Carbon
Engineering

Comments on the APS report on Direct Air Capture

20 June 2011

23 May 2011

CE rendering of APS design. N.B., we did not draw the tower and fan assemblies because it is not clear how APS anticipates adapting pack tower designs to the low depth/high diameter design specified

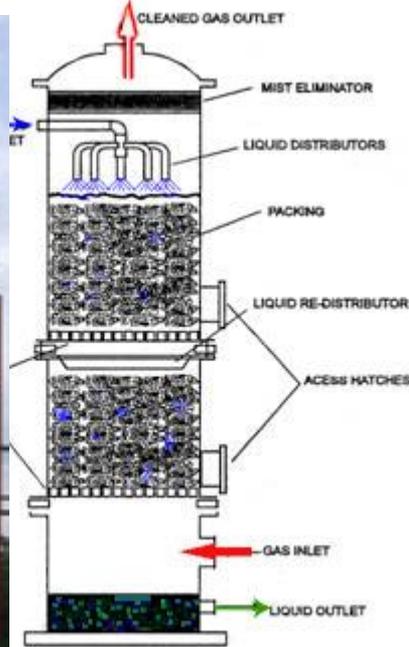
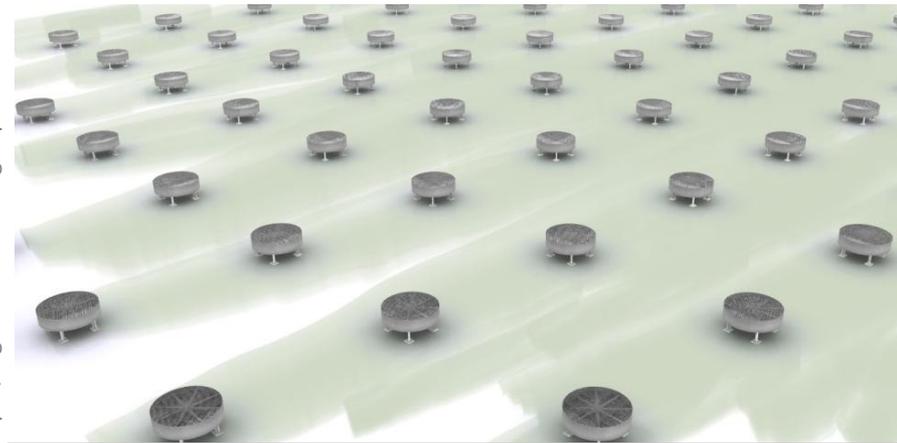
The APS DAC design is costly because:

- The construction and servicing of an array of small towers is more expensive than a large integrated design.
- The cost estimating relations used by APS are, we infer, derived from chemical packed towers that meet the specific requirements of that industry.
- The design is not well adapted to ingesting and rejecting atmospheric air. In the APS design, the low-CO₂ outflow from one tower might be ingested into the next, substantially reducing overall performance.

Our central concern about the APS benchmark cost estimate is that it does not provide a strong technical argument for the choice of industrial analog that is a crucial driver of cost. An alternative choice of analog can produce a dramatically lower cost.
